ADDENDUM 1 – JOB 23434

TO: All prospective bidders on Projects BRJ-0045(075), Job No. 23434 scheduled for the August 9, 2024 bid opening.

PLAN ADDENDUM SUMMARY AND APPROVAL

PROJECT INFORMATION		
Project:	BRJ-0045(075)	PCN: 23434
Location:	0.5 miles west of South Heart, ND	
Date:	08/06/2024	Lead Designer: Charles Hankins, PE
Bid Opening Date:	08/09/2024	JOB#: 23434 Addendum#: 1

BOX CULVERT LAYOUT

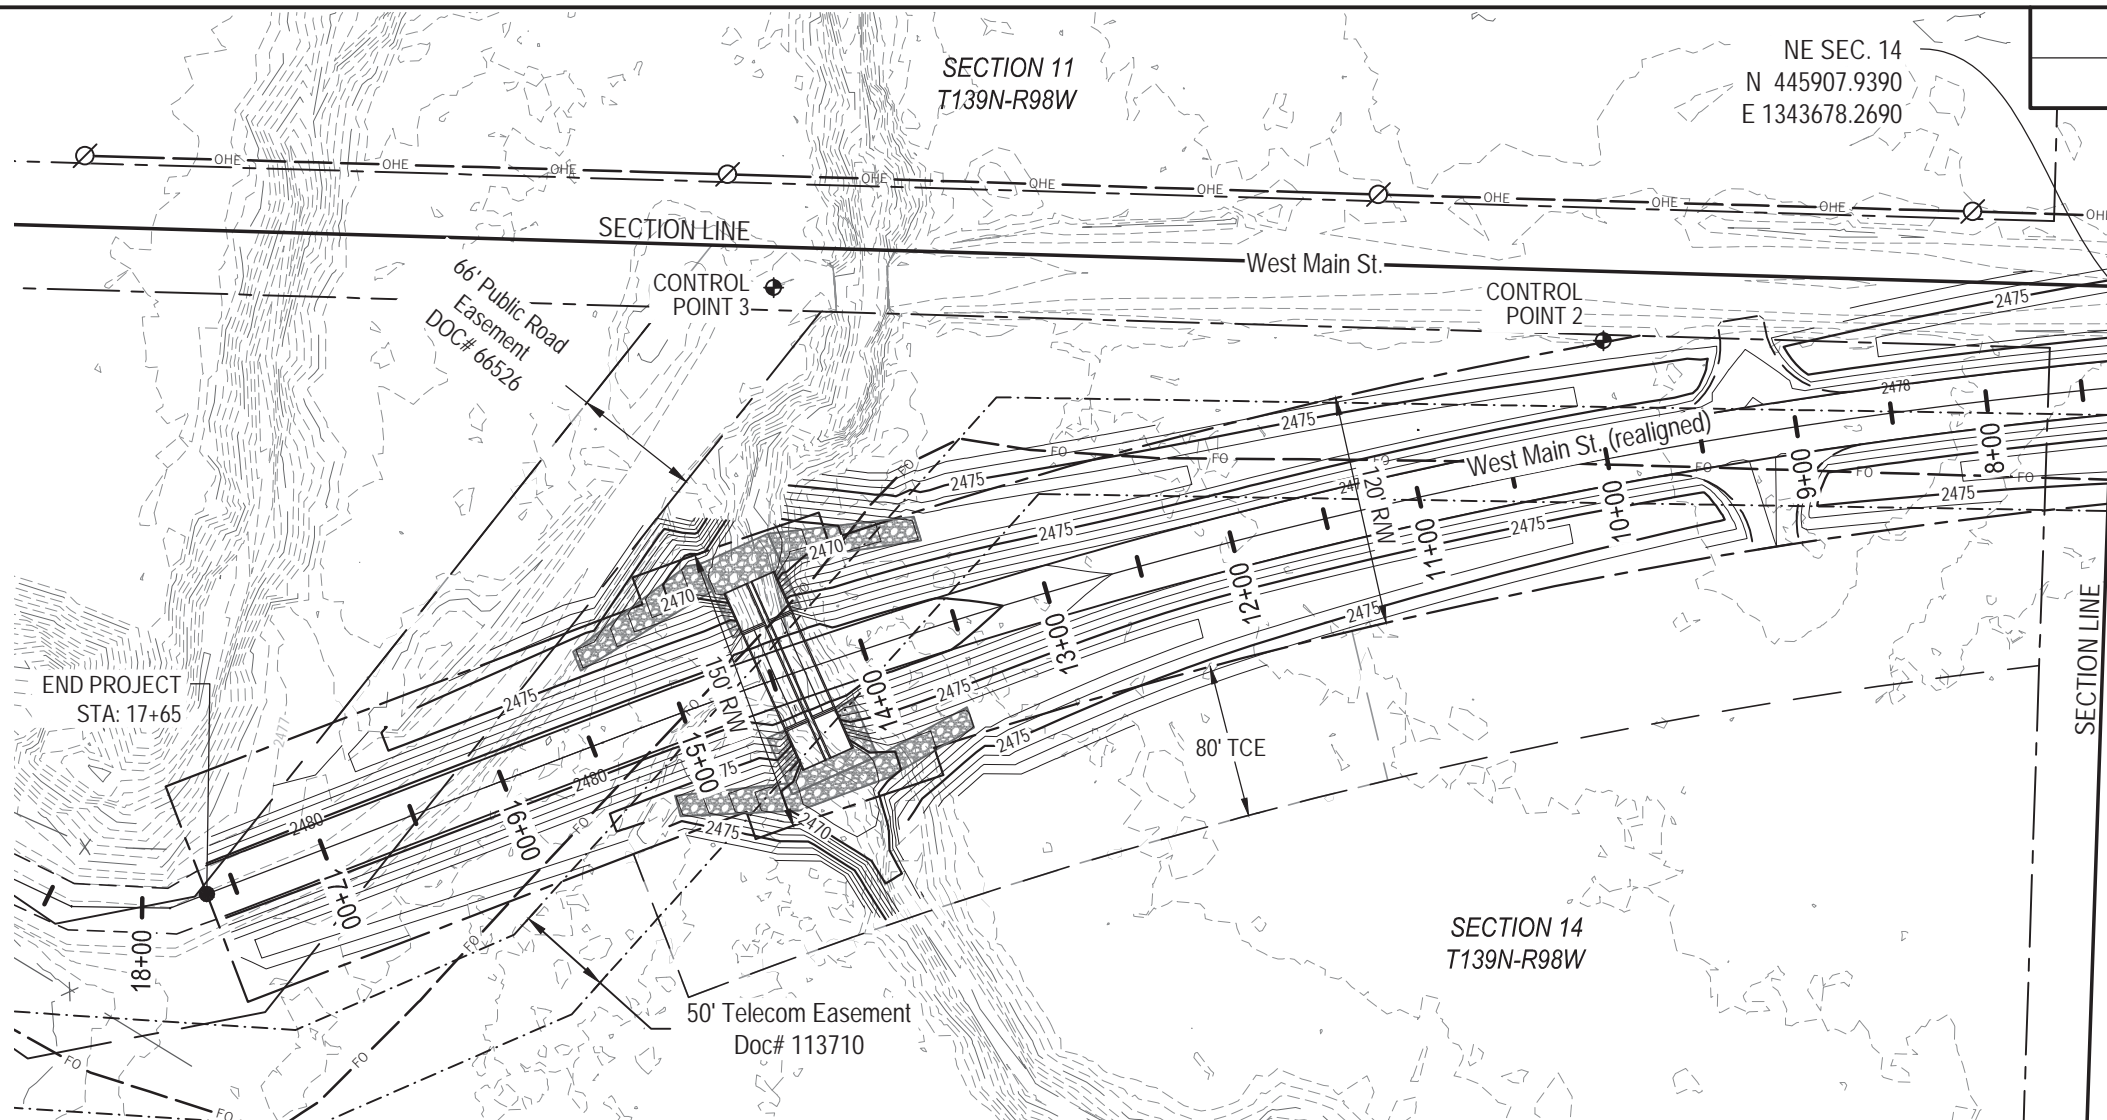
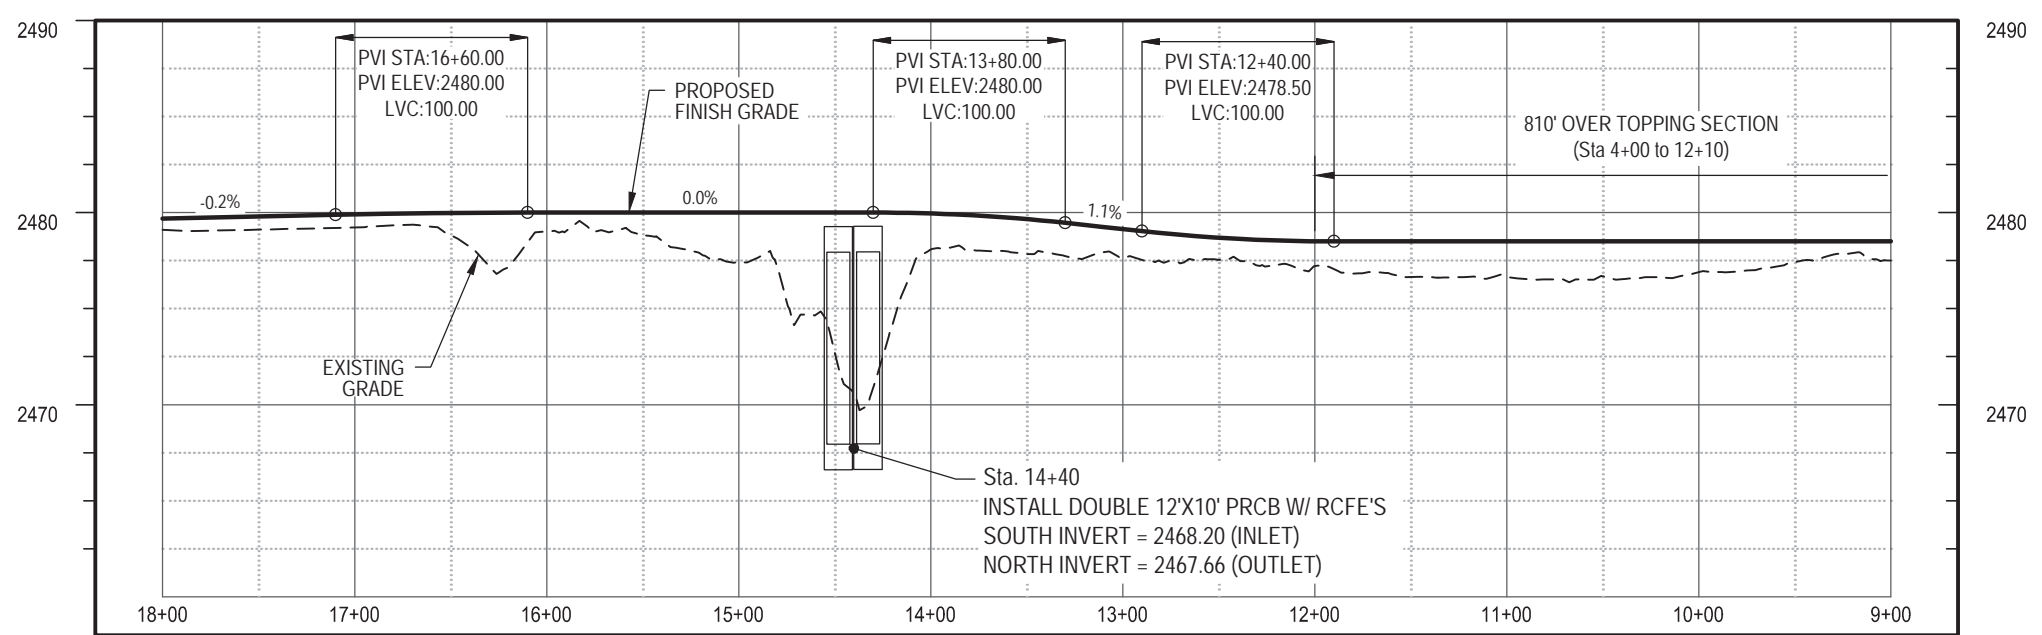
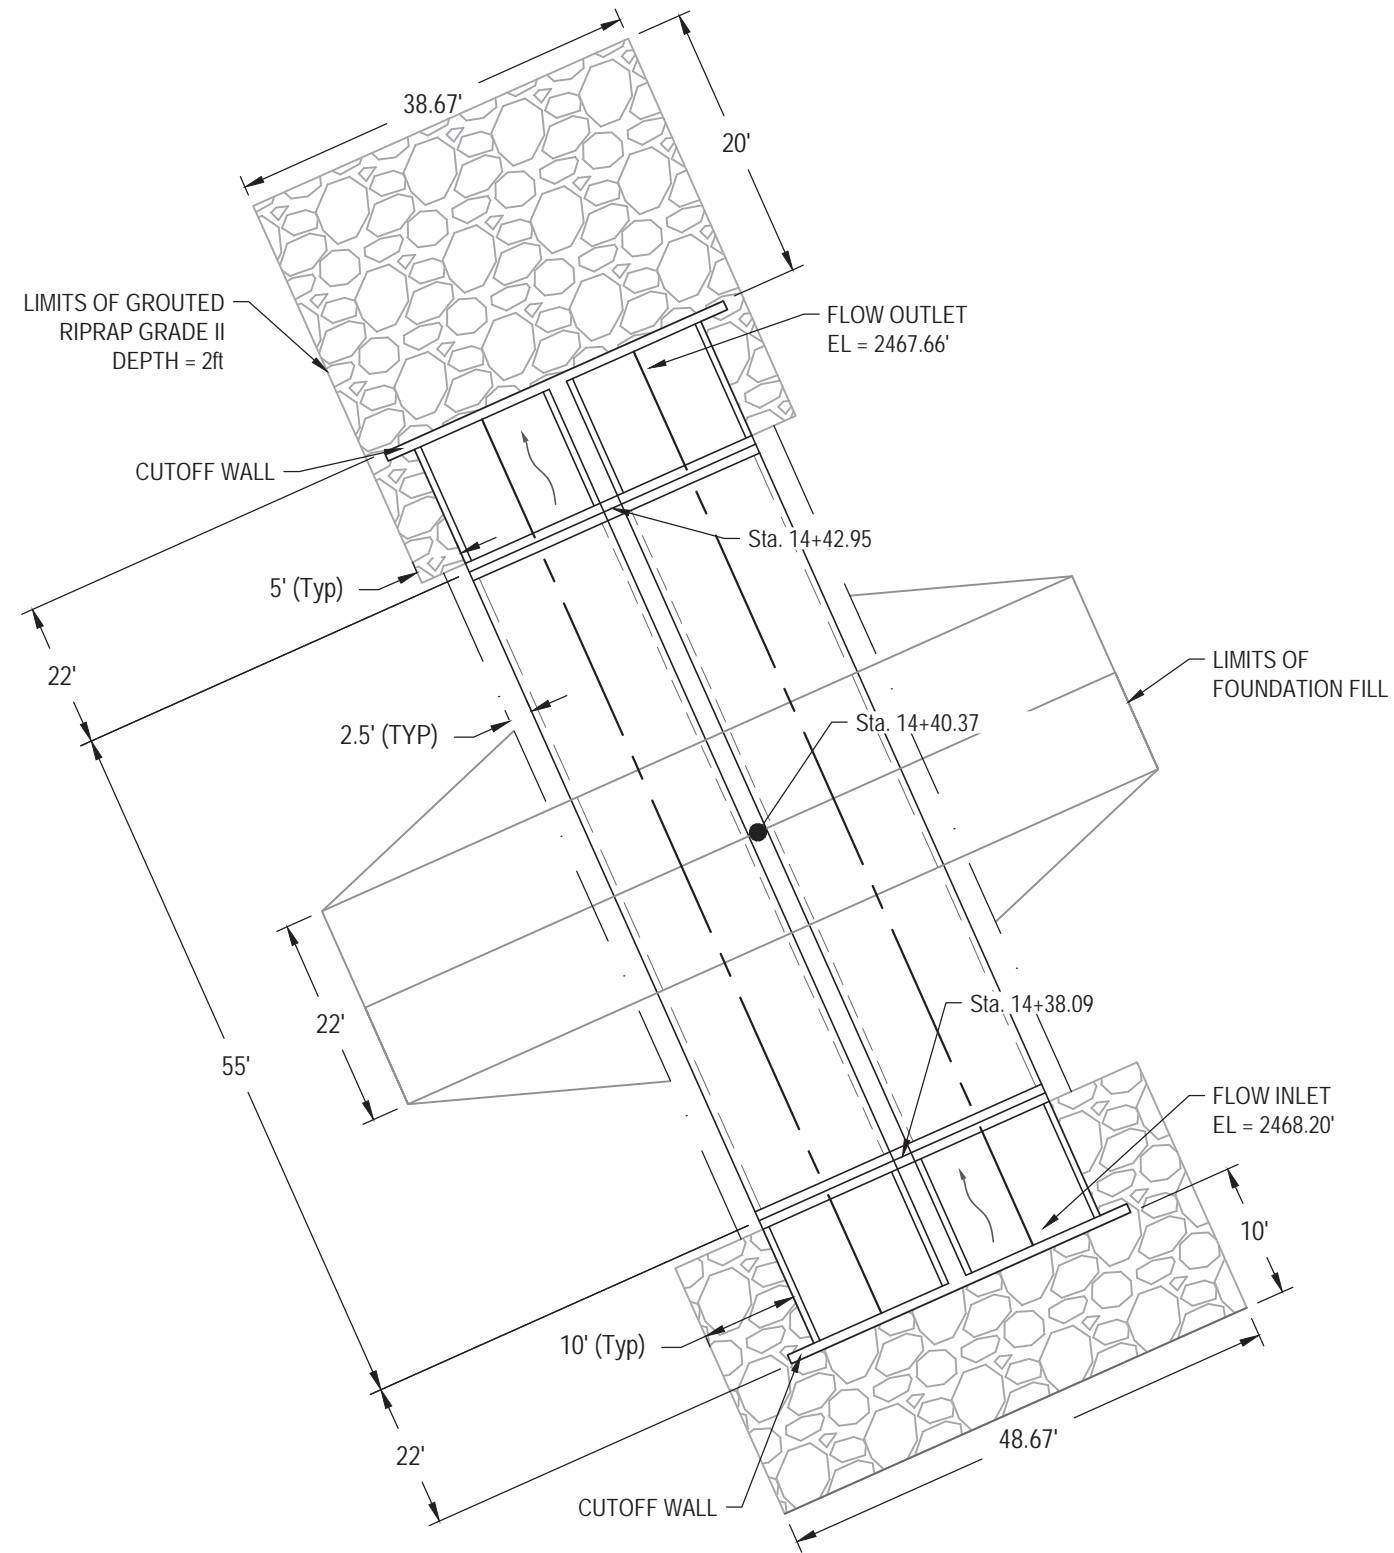
PLAN SHEET CHANGES		
Section	Sheet	Description
4	1	- Remove "COUNTY TO HAUL AWAY" under existing timber structure
6	1	- Add note 201-P01 for new item CLEARING AND GRUBBING - Remove note 203-P04.3 concerning RCBC embankment materials
6	2	- Remove note number 2 from 251-P01 regarding cover crop
6	3	- Change 404 Permit Status to "Secured by Consultant"
8	1	- Add item CLEARING AND GRUBBING - Revise quantity for FOUNDATION FILL - Revise quantity for FOUNDATION FILL-TYPE1 - Revise quantities for DBL 12FT X 10FT PRECAST RCB CULVERT and END SECTIONS
10	1	- Change Tons/CY in Basis of Estimate from 1.5 to 1.875
60	1	- Revise descriptions and quantities for DBL 12FT X 10FT PRECAST RCB CULVERT and END SECTIONS
170	1	- Revise stationing layout on drawing to support DBL RCB CULVERT installation - Change Unit for FOUNDATION FILL from CY to TON
170	2	- Revise the first paragraph under 606-P01 for clarity

CHANGES MADE TO BID ITEMS FOR JOB					
Spec	Code	Description	Unit	Previous Quantity	Revised Quantity
201	0330	CLEARING AND GRUBBING	LS	0	1
210	0209	FOUNDATION FILL	TON	210	909
210	0225	FOUNDATION FILL-TYPE1	CY	213	236
606	3210	DBL 12FT X 10FT PRECAST RCB CULVERT	LF	110	55
606	7210	DBL 12FT X 10FT PRECAST RCB END SECTION	EA	4	2

SPEC.	CODE	ITEM DESCRIPTION	UNIT	QUAN.
210	0050	BOX CULVERT EXCAVATION	EA	1
210	0127	CHANNEL EXCAVATION	L SUM	1
210	0209	FOUNDATION FILL	TON	909
210	0225	FOUNDATION FILL - TYPE I	CY	236
210	0405	FOUNDATION PREPARATION BOX CULVERT	L SUM	1
256	0200	RIPRAP - GRADE II	CY	648
256	1000	GROUT FOR RIPRAP	SY	208
